Grobbel Environmental & Planning Associates

November 10, 2014

RE: Review of Stormwater Management and Soil Erosion Control Measures, GTTC/VGT, M-72 Highway, Acme Township, Grand Traverse County, Michigan from November 7, 2014 Site Visit.

Photograph #23: Topsoil and erosion control matting being placed at the swale in the south-southwestern portion of the GTTC/VGT property looking easterly. Taken by C. Grobbel, Grobbel Environmental & Planning, November 7, 2014.

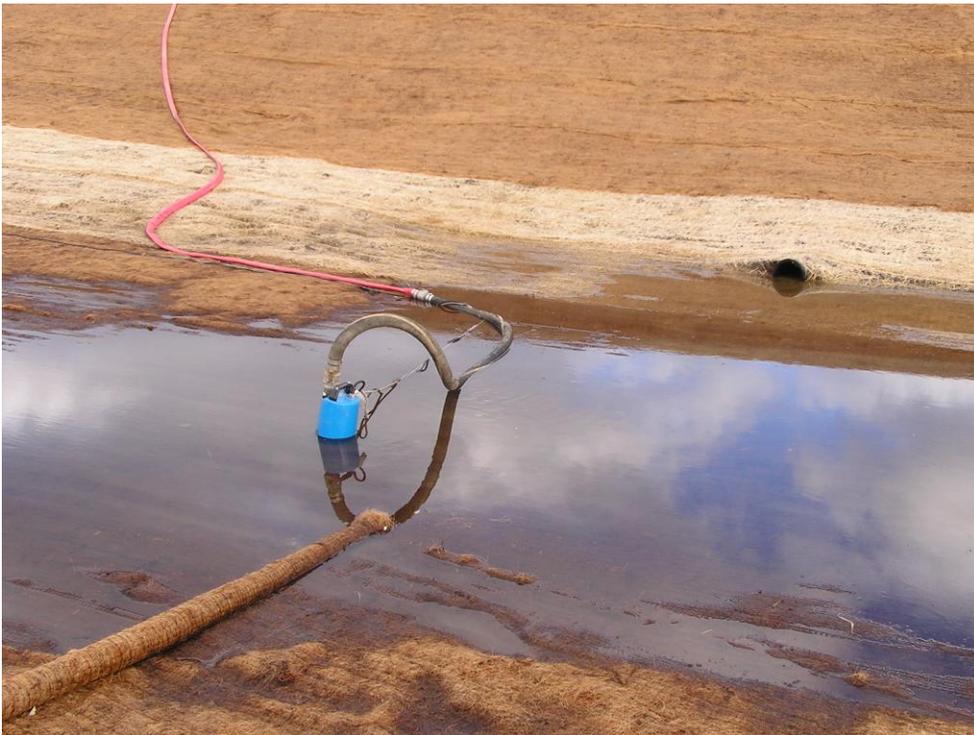
- 3) **Swale at South-southwest Portion of the GTTC/VGT Site** – As shown in Photographs #23 through #28 below, top soil and erosion control matting has been properly placed within the swale at the south-southwest portion of the GTTC/VGT property. No sediment was observed on

November 7, 2014 beyond the silt fence/straw bale structure at this location, and no impact to downgradient wetlands or Acme Creek was observed. *It is recommended that the swale be effectively stabilized through vegetation as soon as possible at this location.*
